**Response to clarifications on Notice of Requirement to Alter City Rail Link Limited Designation 2501 in the Auckland Unitary Plan (Operative in Part)**

We write in response to your 5 August 2021 request for clarifications in respect of the City Rail Link Limited (CRL) 'Notice of a Requirement to Alter City Rail Link Limited Designation 2501 in the Auckland Unitary Plan (Operative in Part)'.

Figure 1 Soundsplash image for a 2 metre high noise barrier

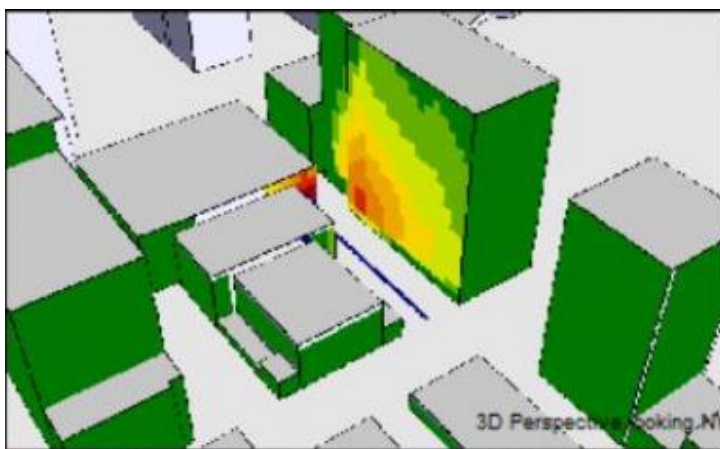
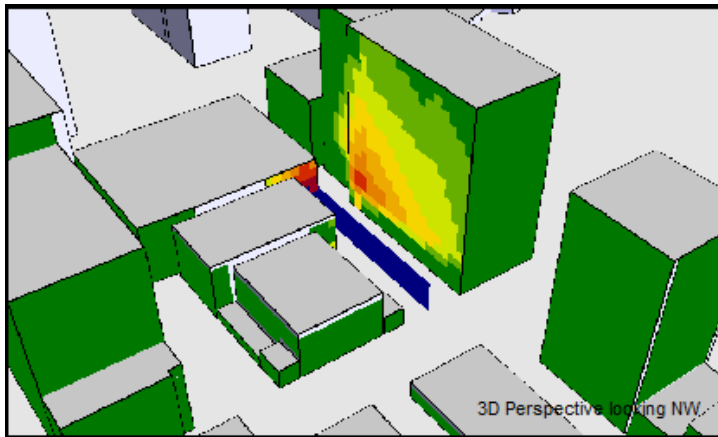
*A more robust consideration of a taller screen/barrier (higher than 2m) is needed as part of the BPO assessment rather than deferring this matter to when the site is established (as currently intended in Section 3.5 of CNMP). If a taller screen has been identified as the BPO, this will also require updates to the CNMP.*

The CRL project noise specialist (James Whitlock from Marshall Day Acoustics) confirms that a 10-metre high acoustic barrier (which is taller than would be practicable) was modelled. Soundsplash images for a 2-metre and 10-metre high barrier are shown respectively in Figure 1 and Figure 2 below. The images illustrate that even a 10-metre high barrier cannot achieve compliance on the façade of buildings on the north side of Tyler Street due to the geometry of the situation. As a higher barrier would not provide any additional benefit, it is considered that a 2-metre barrier is the best practicable option.
